TECHNICAL GUIDANCE COMMITTEE FOR INDIVIDUAL AND SUBSURFACE SEWAGE DISPOSAL

December 11, 2002 MEETING MINUTES

Example of Filter, Valve and Meter Assembly.

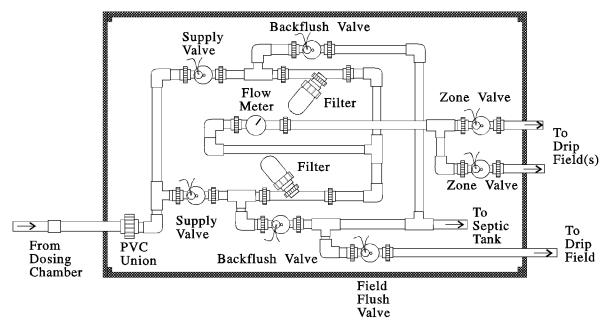
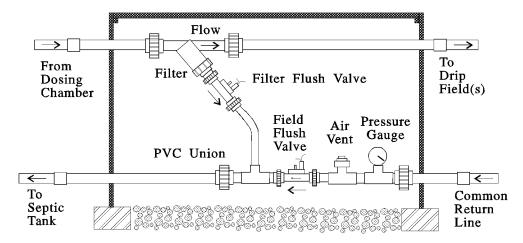
The TGC requested that Figure 1 include the option to route the field flush line straight to the septic tank rather than through the filter, valve, and meter box. The TGC requested an additional figure of the filter, valve, and meter box assembly.

GRAYWATER SYSTEM (Single Tank - Gravity)

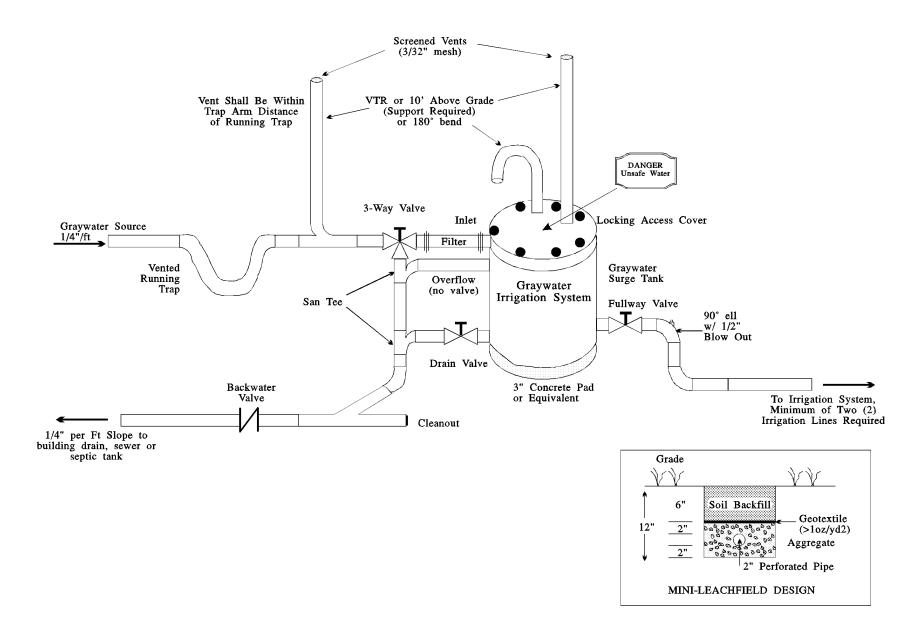
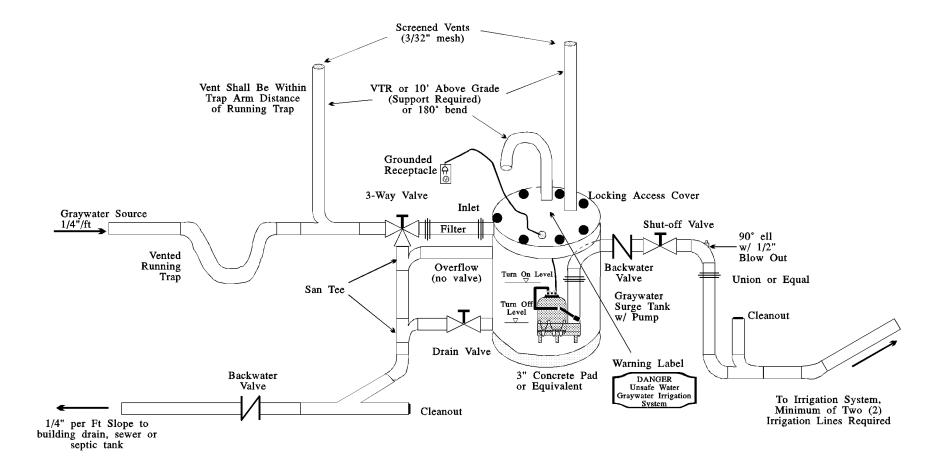
The Committee modified the figures by eliminating the depiction of the ground surface, and to move the label from the side of the surge tank to the tank access lid.

7. Dosing Chamber:

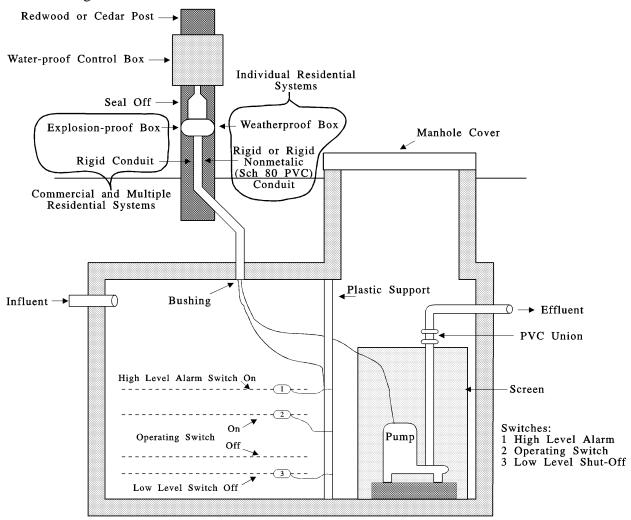
?? Revise the figure to indicate that a weatherproof box is acceptable for individual residential systems and that the conduit can be rigid nonmetalic schedule 80 PVC. Note that the explosion-proof box is required for multiple residential and commercial applications.

4) An acceptable circuit is shown in the following diagram:

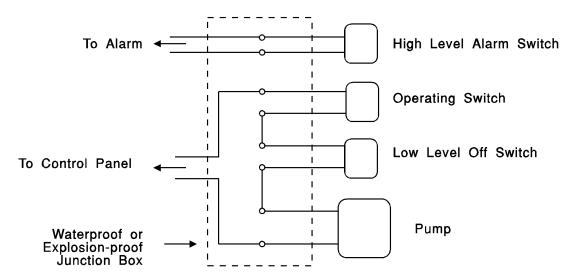
- ?? Revise language in 2) to reflect changes in electrical requirements and suggested language changes from the Electrical Bureau.
- ?? Revise figure in 4) by adding "weatherproof or" to text describing electrical box (TGM page 59).
- ?? Revise language in 5) and 6) to refer to the Division of Building Safety, Electrical Bureau.
- ?? Revise figure in 6) to indicate the use of rigid or rigid nonmetalic (SCH 80 PVC) conduit is acceptable materials to run electrical wire, and add weatherproof to the descriptor for the connection box.
